## *City of El Paso – City Plan Commission Staff Report*

**Case No:** SUSU12-00016 Festiva Hills Addition Replat “A”  
**Application Type:** Resubdivision Combination  
**CPC Hearing Date:** April 19, 2012

**ATTACHMENT 4**

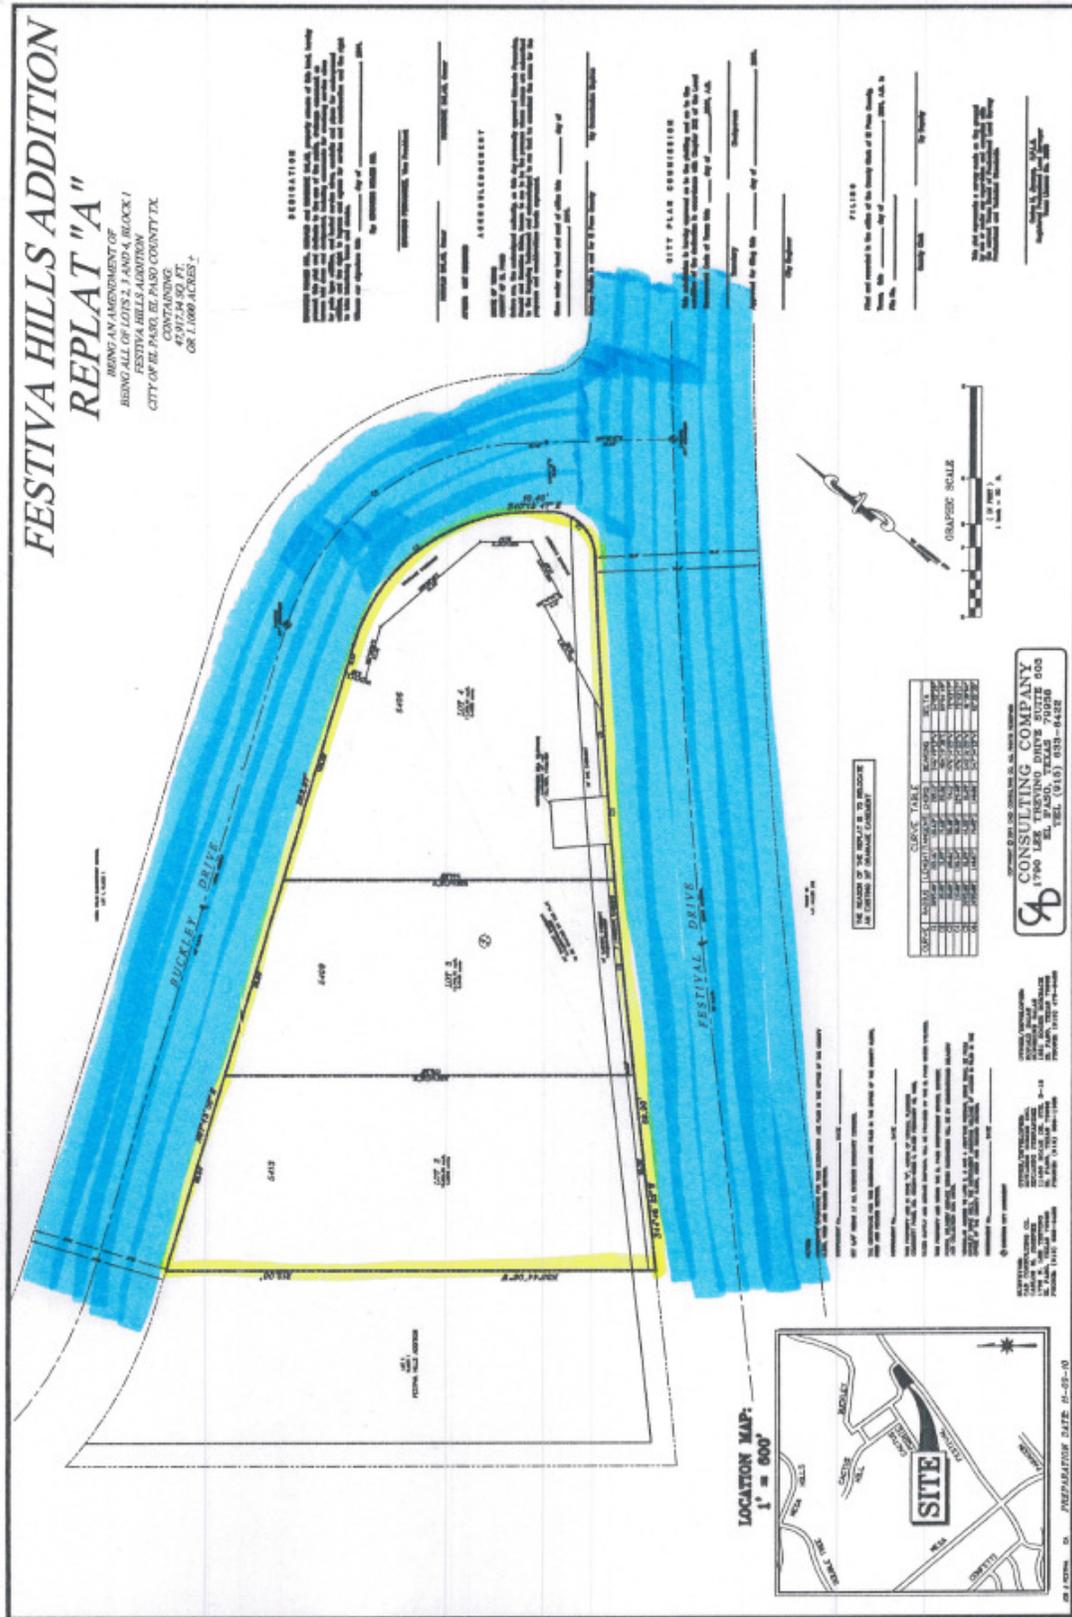
1. **Erosion Control Wall** is required at the property line of **Festival Drive R.O.W.**

1. Submit to the Planning and Economic Development Department – Planning Division the following prior to recording of the subdivision.
  - a. Current certified tax certificate(s)
  - b. Current proof of ownership
  - c. Release of access document, if applicable
  - d. Set of restrictive covenants, if applicable
2. Every subdivision shall provide for postal delivery service. The subdivider shall coordinate the installation and construction with the United States Postal Service in determining the type of delivery service for the proposed subdivision. In all cases, the type and location of delivery service shall be subject to the approval of the United States Postal Service.
3. Applicant shall address the following comments prior to recordation:
  - Remove 3-ft landscape easement from plat graphic.
  - All lettering on the plat shall be legible.
